SPECIFICATION, SPECIAL PROVISIONS AND DRAWINGS
REVISION TO STANDARD SPECIFICATIONS AND DRAWINGS

PROPOSAL TO STANDARDS COMMITTEE

PROBLEM(S) ENCOUNTERED: Bridge Standards 707 thru 731 need to be revised and updated for content and presentation.

APPROVED MINUTES ITEM 03

EXISTING 707-BPBB-01 BRIDGE PRESTRESSED BOX BEAM ADJACENT BOX BEAM (PROPOSE TO DELETE)

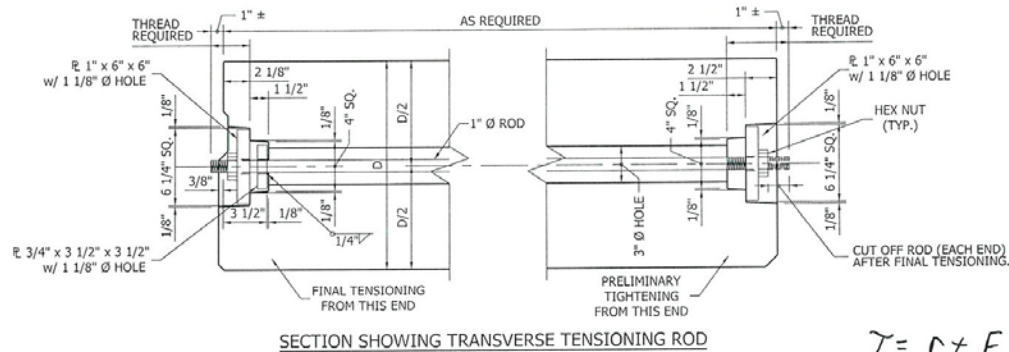
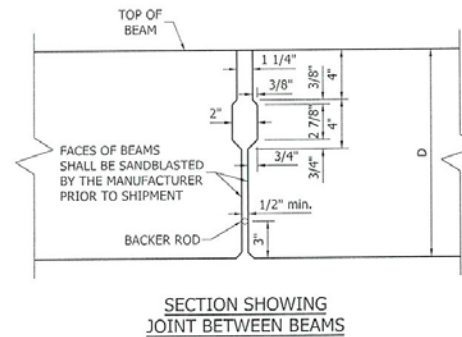
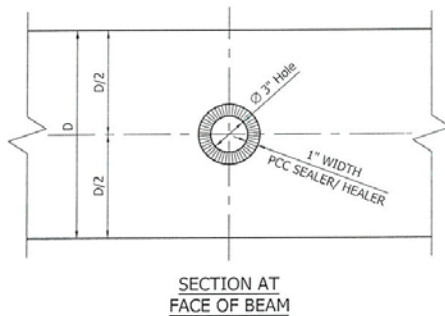
1" ϕ rod
 $A = \pi r^2 = 3.14159(.5)^2$
 $A = .785"$
 $.785 \times (29,000 \times 15/16) =$
 15707 lb
 15707 lb/rod

$T = r + F$

EXISTING IDM FIGURE 406-12A ADJACENT BOX BEAM WITH TRANSVERSE TENSIONING RODS (PROPOSE TO DELETE)

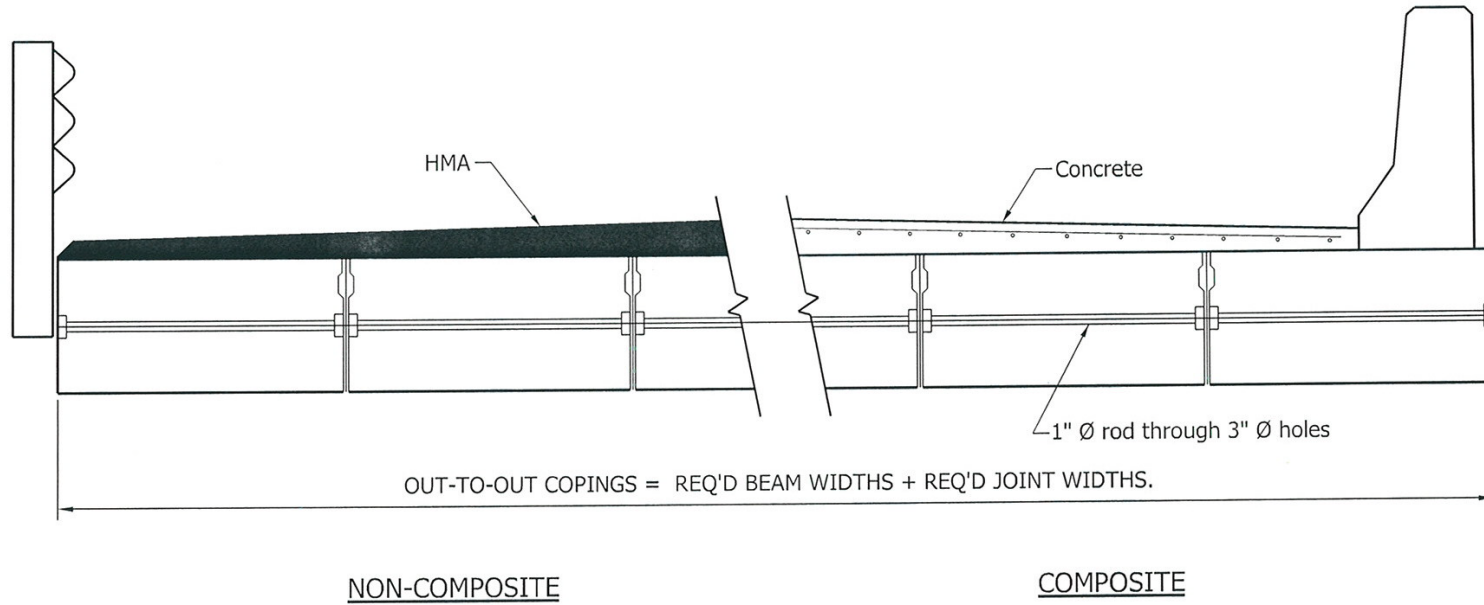
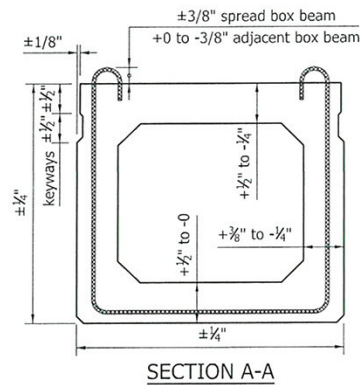
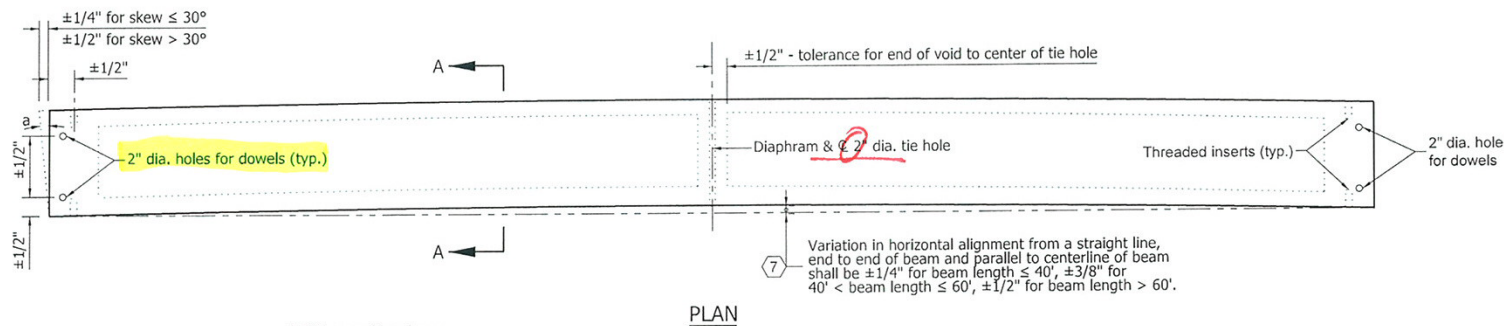
APPLICABLE DESIGN MANUAL SECTION: 406-12A Figure showing transverse tensioning rods will be deleted.

EXISTING 707-BPBF-01 FABRICATION TOLERANCES PRESTRESSED BOX BEAM (WITH MARKUPS)

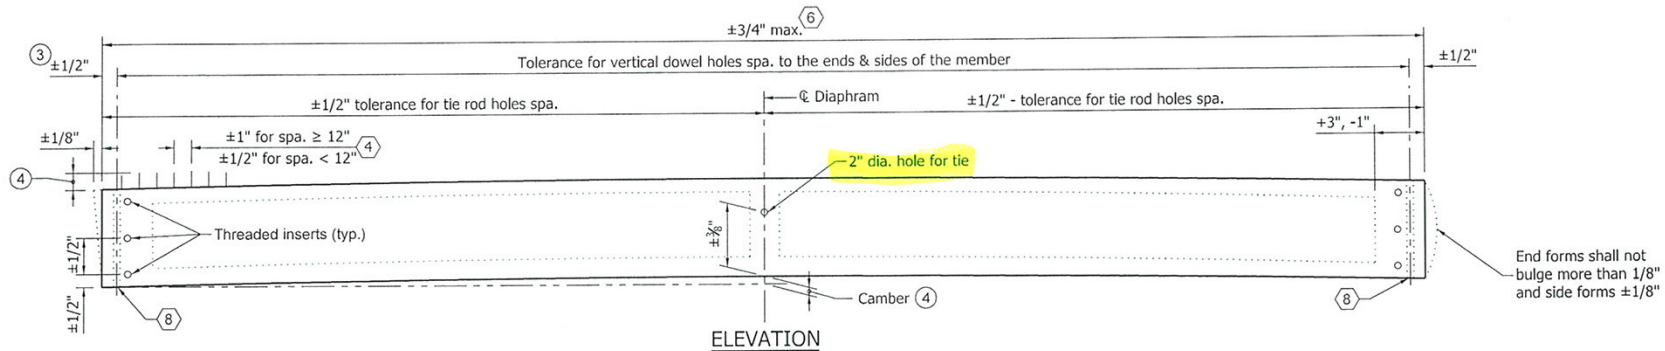
- See Standard Drawing E 707-BPBF-04 for General Notes.
- The top surface of the beam shall not vary more than 1/8" in 10' as measured from a straightedge.
- ③ Tolerance of beam ends for deviation from a true vertical with respect to top and bottom surfaces.
- ④ Projection above top of spread box beam shall be ±3/8". Projection above top of adjacent box beam +0 to -3/8".

EXISTING 707-BPBF-02 FABRICATION TOLERANCES PRESTRESSED I BEAM (WITH MARKUPS)

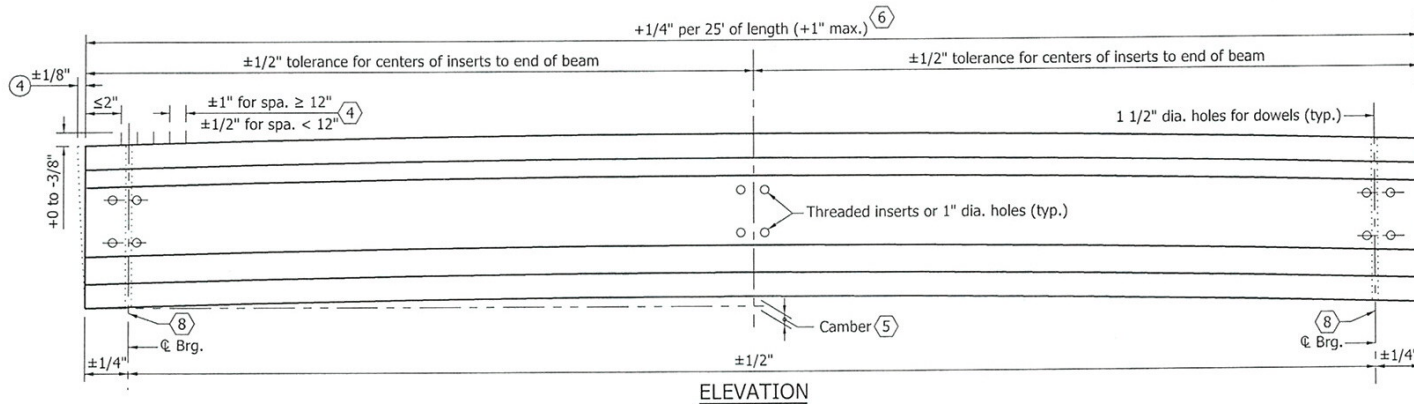
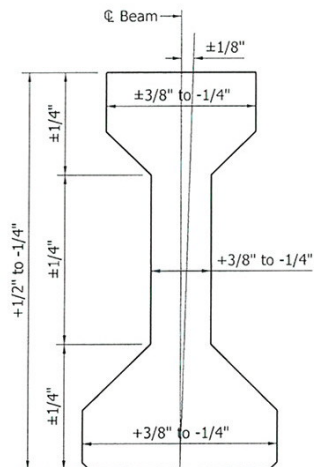
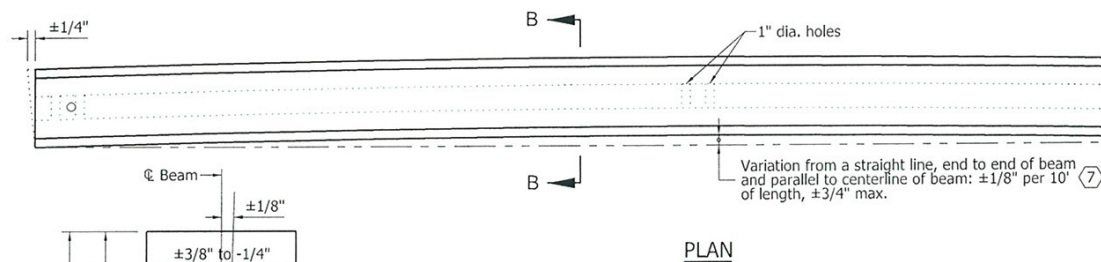
Tolerance added for holes

EXISTING 707-BREB-01 STEEL STRUCTURES (PROPOSE TO DELETE)

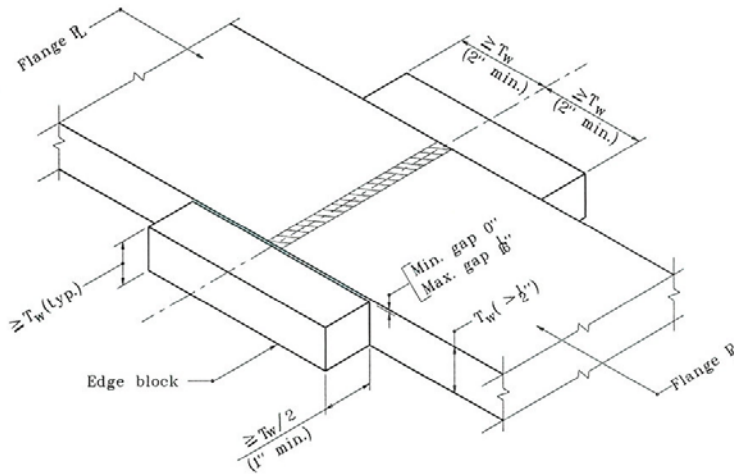
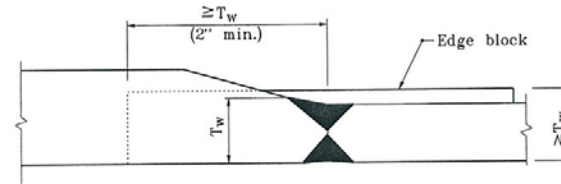
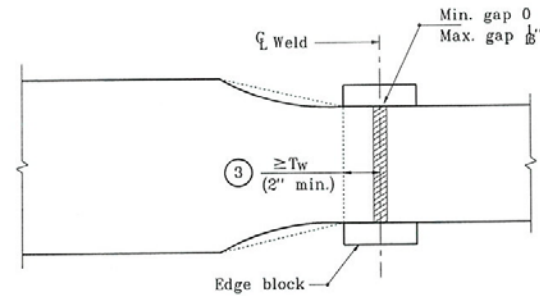
Mike McCool IDM fig 407-1C

6.2 AASHTO/AWS D1.5:2010

EXISTING 711-BSTS-01 FIXED STEEL SHOE DETAILS (PROPOSE TO DELETE)

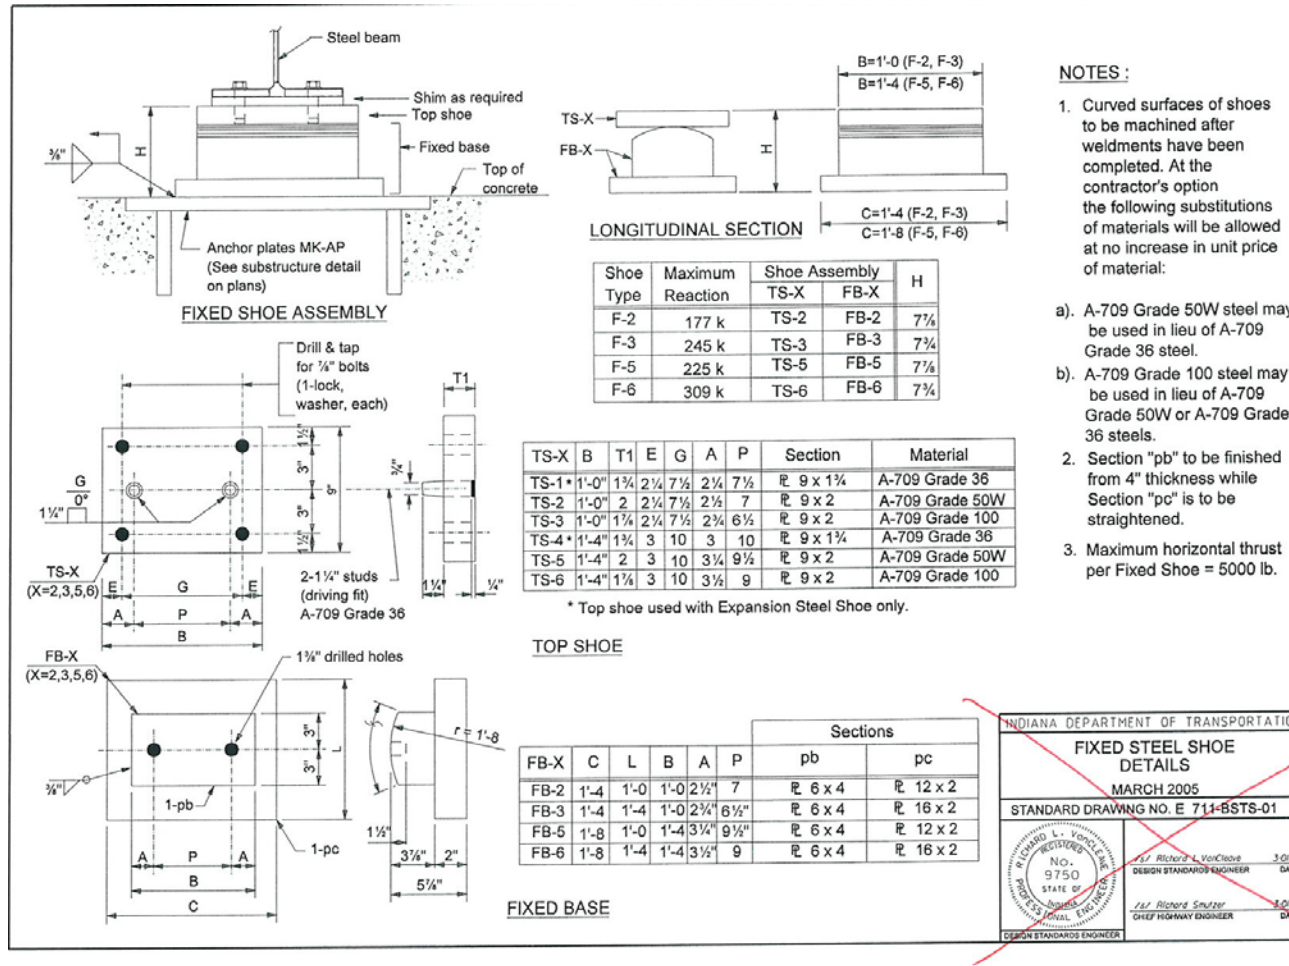
AASHTO 19.7
Such details should be avoided.
High risk of loss of bearing

EXISTING 724-BJTS-02 TYPE BS EXPANSION JOINT (PROPOSE TO DELETE)

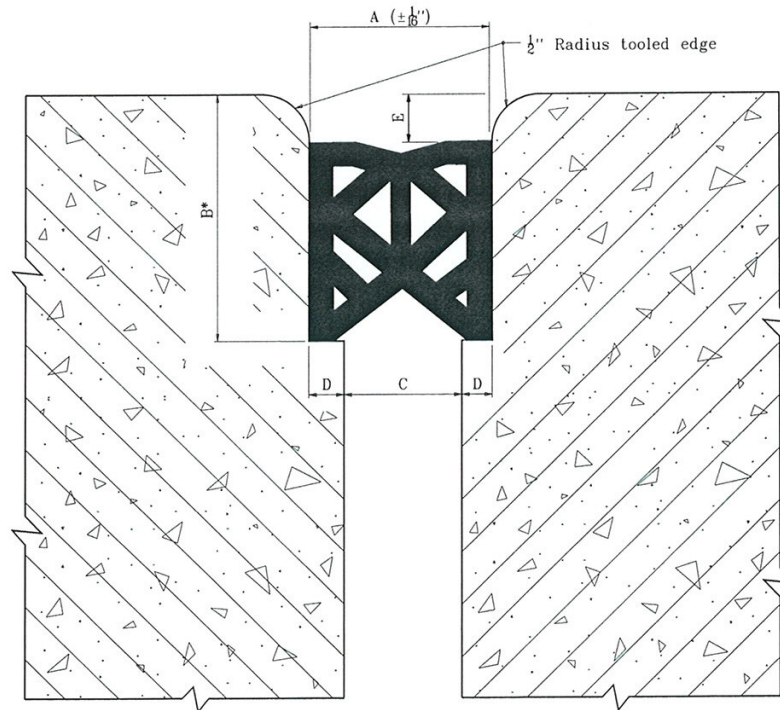
Standard was to be deleted - has not been approved for use for several years.

EXISTING 724-BJTS-06 OPTIONAL RAILING VERTICAL REINFORCEMENT SPLICE (PROPOSE TO DELETE)

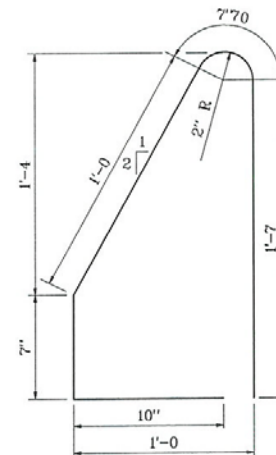
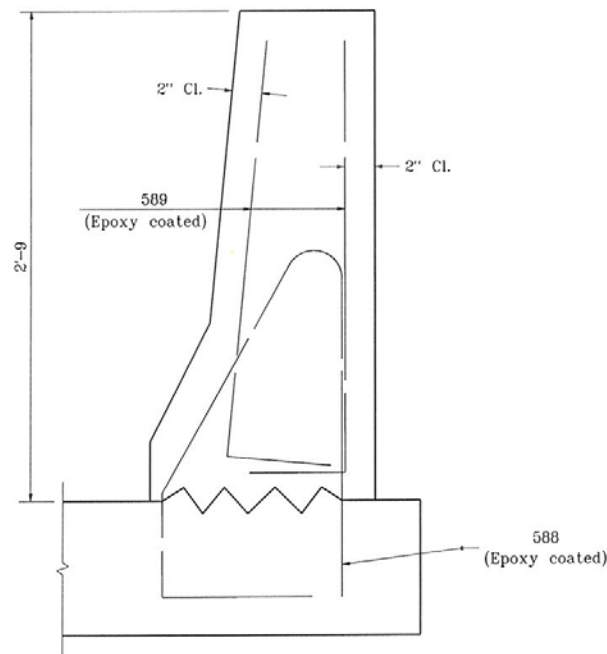
*This alternate can not be allowed.
This reinforcement configuration has not been crash tested.*

731-MSEW-01 MSE WALL PRECAST CONCRETE COPING (DRAFT)

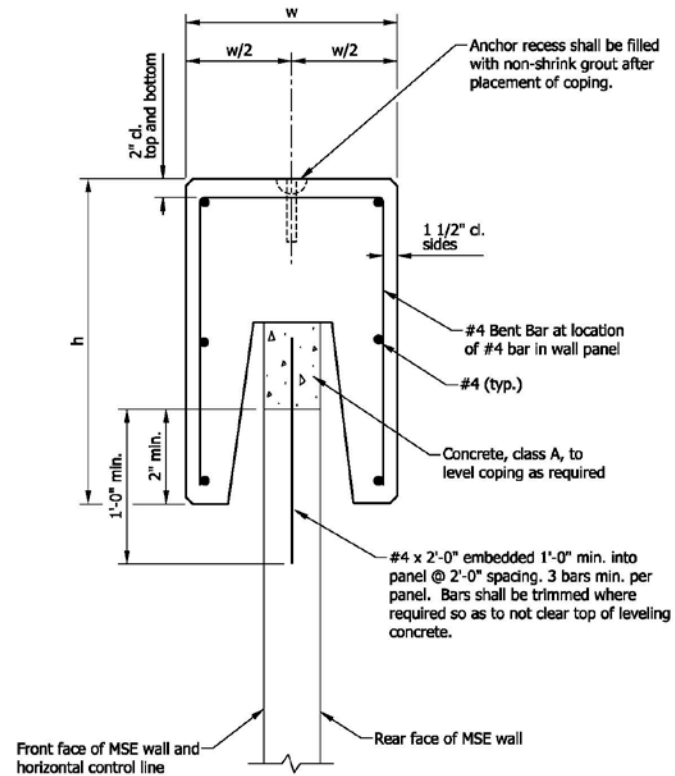
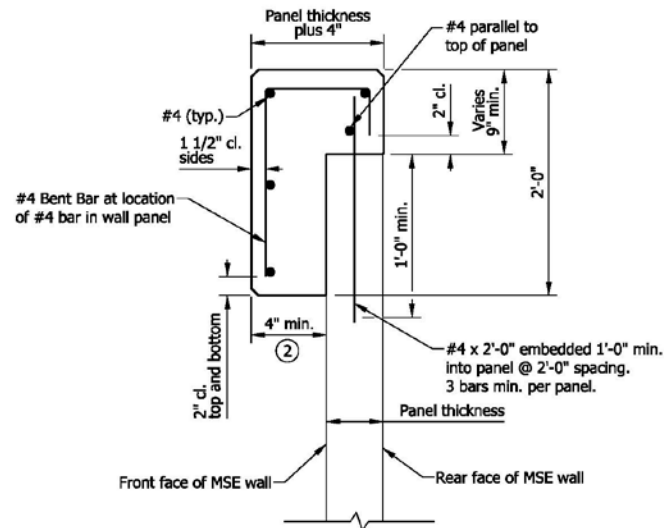
Mr. Miller asked about the MSE wall coping, and if it is resting on the wall by gravity, or if reinforcing bars are sticking up and grouted into the coping (agenda page 26). Mr. Reilman stated that it appears to be not tied down and just sits on there, held down by gravity. Mr. Strain suggested that be looked at by the wall committee, to prevent the meandering appearance of the coping. Mr. Pankow suggested a tighter fit might help. Further discussion revealed that the copings fit too loosely and should be a tighter fit to prevent the pieces from moving around so much.
